A G E N D A
KEIZER CITY COUNCIL
EXECUTIVE SESSION

AGENDA
KEIZER CITY COUNCIL
REGULAR SESSION
Monday, September 21, 2015
7:00 p.m.
Robert L. Simon Council Chambers
Keizer, Oregon

- a. Comprehensive Plan/Zone Change/Lot Line Adjustment/Subdivision - Appeal of Hearing Officer Decision – Property at 5447 and 5457 Burbank Street N, Keizer, Oregon
- b. Application of KS REIM, LLC for Reimbursement District Formation
- c. **ORDINANCE** – Amending Keizer Development Code Section 1.200 (Definitions); Amending Ordinance No. 98-389; Declaring an Emergency

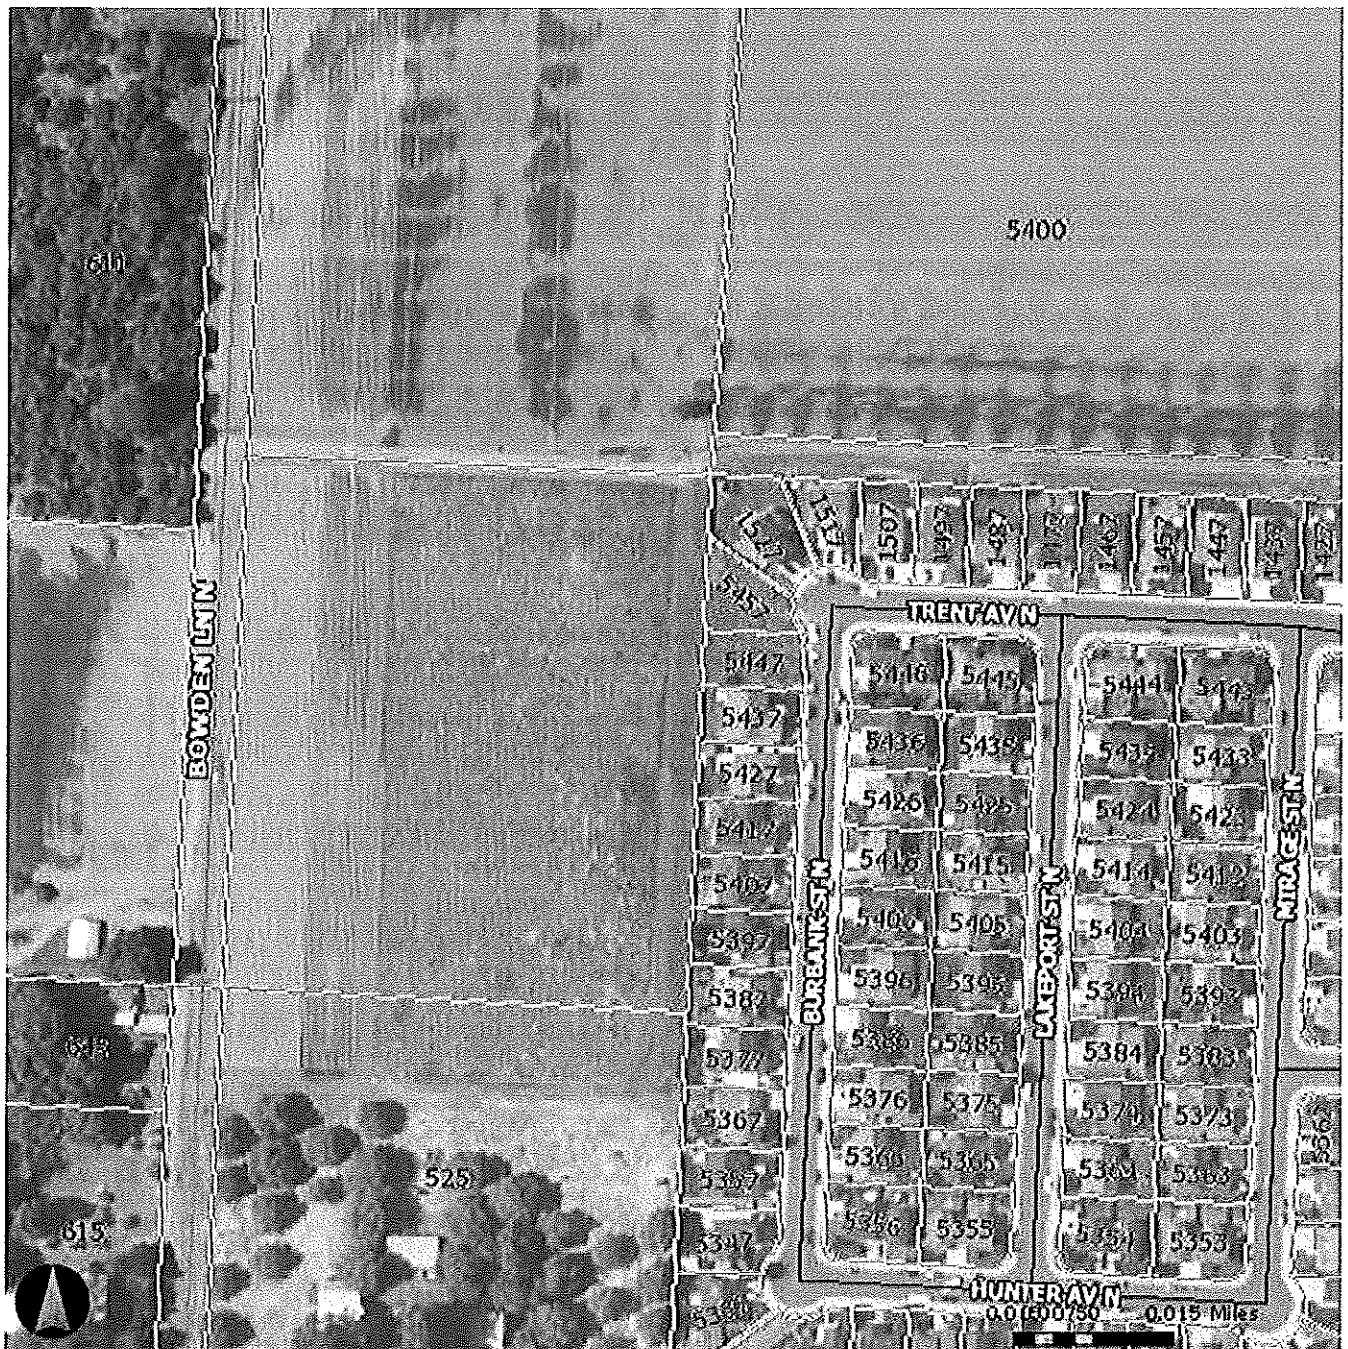
Sorry about the confusion. The 26 feet is a typo and should say 46 foot. So the site plan is correct with a 32 foot wide street within a 46 foot wide row.

Exhibit '2A'
Revised

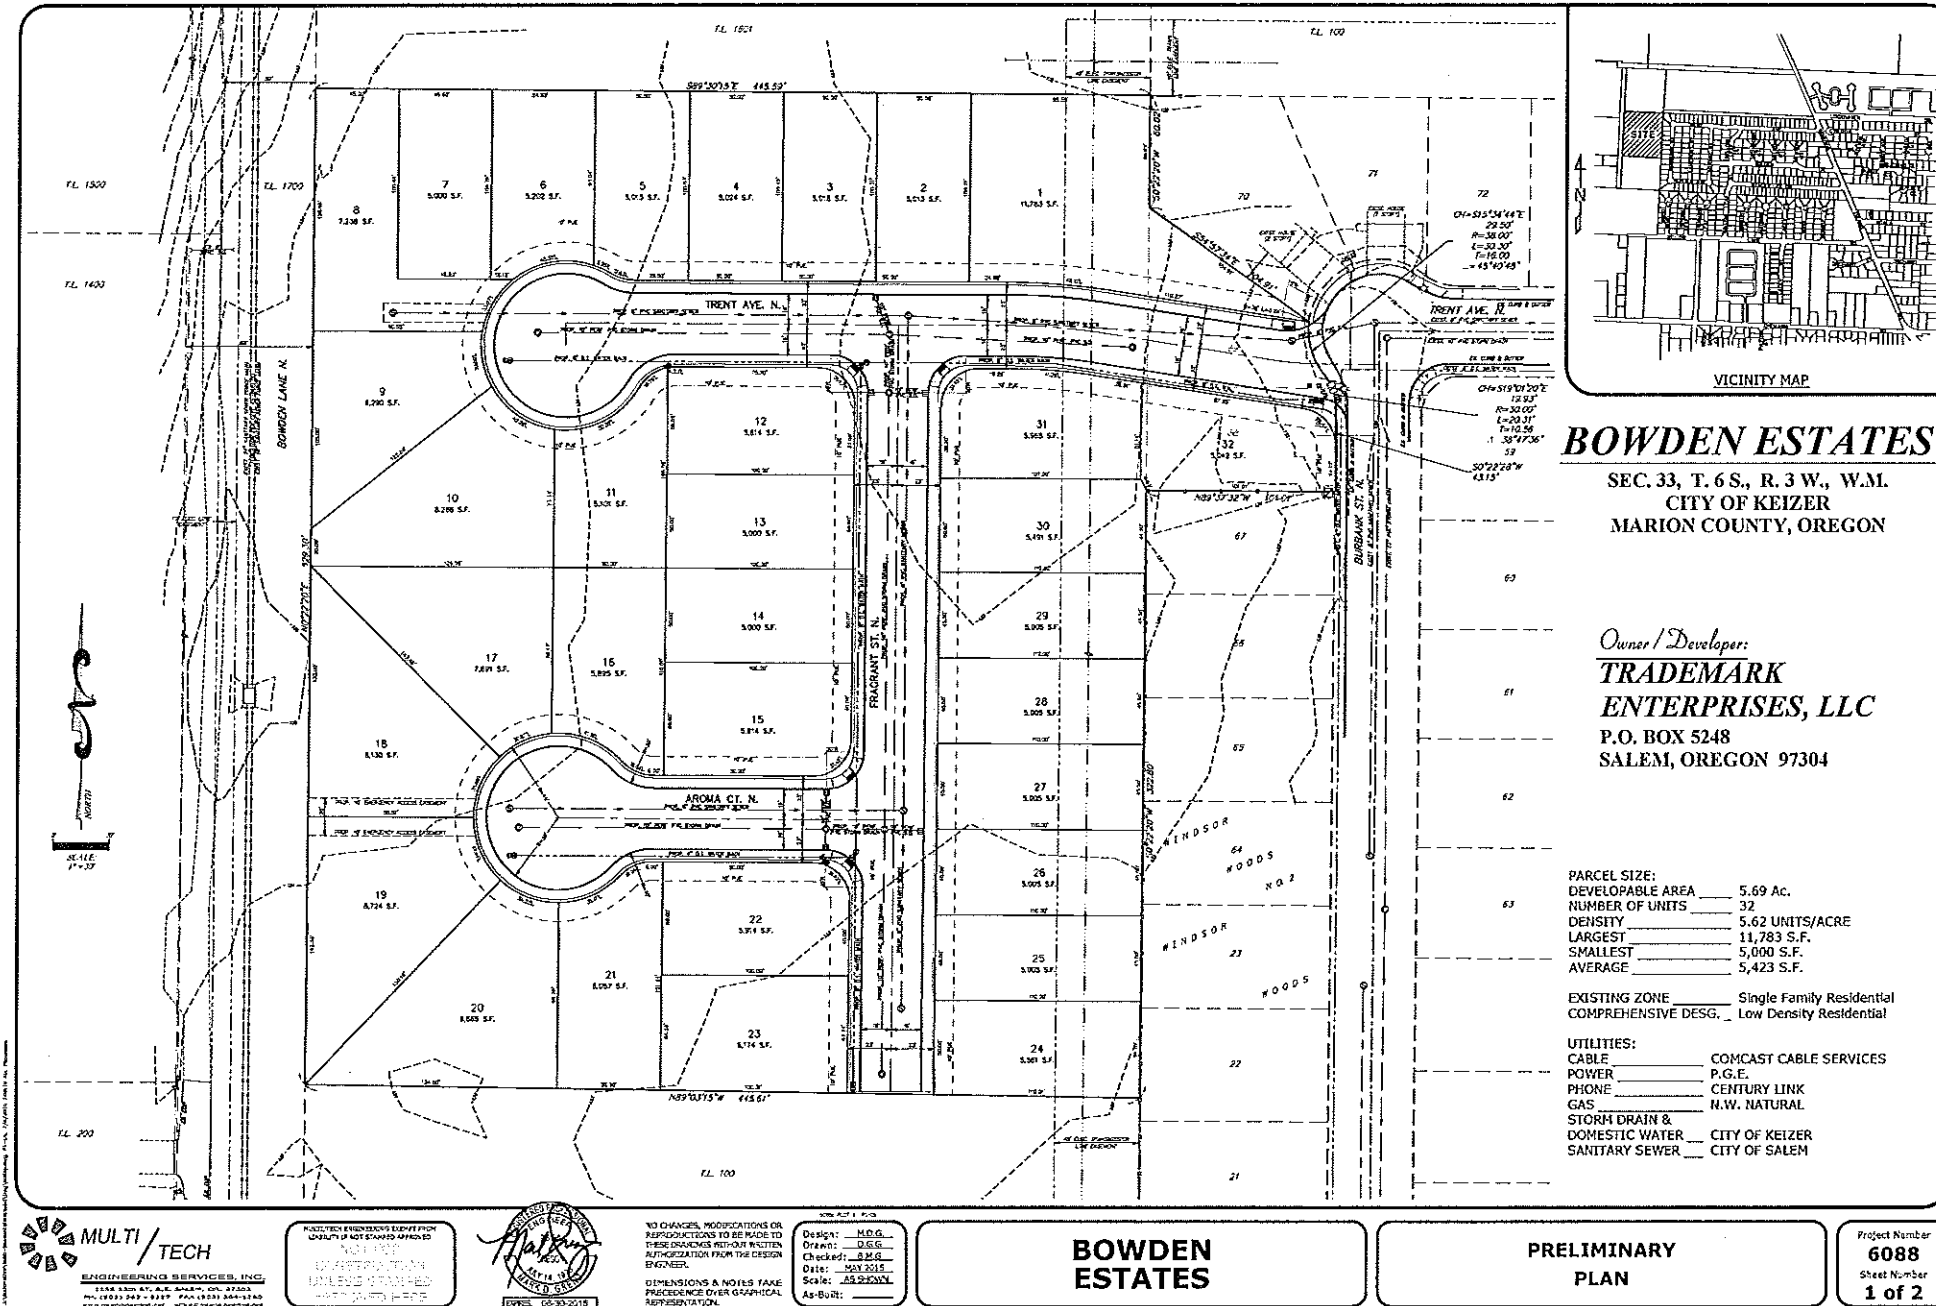
After the appeal was submitted, staff met with the applicant's agent to better understand the reasons for the appeal and to express Public Works concerns and to determine if an alternative could be developed that would satisfy those concerns. Following that meeting a revised alternative was developed by an independent traffic engineer identified as "Alt B" for review by staff. This alternative includes a stop sign at Burbank Street, no parking along two sections of Trent Ave at the intersection and raised reflective bi-directional placement markers through the intersection. (See attached drawing.) Staff believes this revised alternative addresses the concerns of both the Hearings Officer and the City Engineer, and staff supports this alternative. The revised street alignment will allow a street intersection that will be safe for both residents in the existing neighborhood as well as for the future residents of the new subdivision.

That the City Council open the public hearing to consider the appeal, and if there are no questions, close the hearing. Staff recommends that City Council reverse the Hearings Officer's decision, subject to the alternative referenced above being placed as a condition of approval and direct staff to prepare an order with appropriate conditions of approval.
